Access Compliance Report Public Rights-of-Way (Curb Ramps)

Main Street: **RODEO_DR** Cross Street: **CERRITOS_AVE** Location: **SW**

ADA ID: **RPRK210922111357** Ramp Type: **Type 1 - Perpendicular Diagonal** Initial Pass/Fail: **Fail** Overall Compliance: **No** Severity Score: **15**

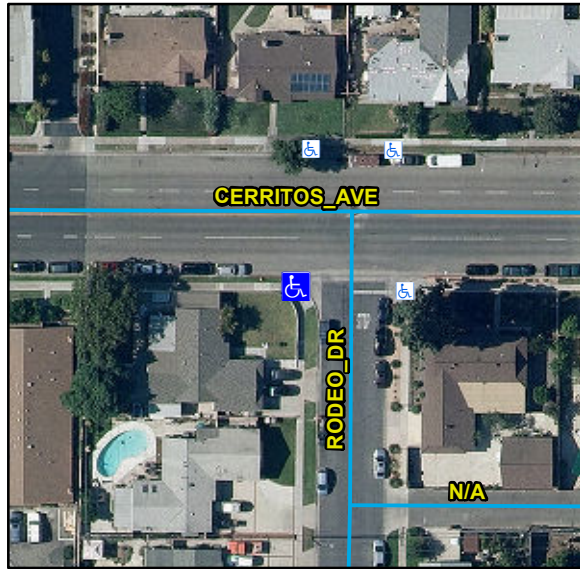
Compliance	Description	Data	Compliance	Description	Data
N/A	Ramp Length (in)	96	N/A	Flare Type LT	
Yes	Ramp Width (in)	48			N/A
No	Ramp Run Slope (%)	9.3	N/A	Flare Slope LT (%)	N/A
Yes	Ramp Cross Slope (%)	1.7	N/A	Flare Traversable LT	N/A
N/A	Landing Present	N/A	N/A	Flare Type RT	
N/A	Landing Length (in)	N/A			N/A
N/A	Landing Width (in)	N/A	N/A	Flare Slope RT (%)	N/A
N/A	Landing Run Slope (%)	N/A	N/A	Flare Traversable RT	N/A
N/A	Landing Cross Slope (%)	N/A	N/A	DWS Provided	N/A
N/A	Landing Movement Obstructed?	N/A	N/A	DWS Contrast	N/A
	Landing Movement Type	N/A	N/A	DWS Length (in)	N/A
N/A	Landing Shared	N/A	N/A	DWS Full Width	N/A
N/A	Clear Space	Yes	N/A	DWS Offset Left (in)	N/A
N/A	Clear Space To Crosswalk (in)	N/A	N/A	DWS Offset Right (in)	N/A
N/A	Marked Crosswalk 1	No	N/A	Marked Crosswalk 2	No
	Crossing 1 Direction	E		Crossing 2 Direction	N
	Marked Crosswalk 1 Width (in)	N/A		Marked Crosswalk 2 Width (in)	N/A

Remove & Replace Curb Ramp With Two New Directional Ramps or Equivalent.

R304.2.2, STD 1115
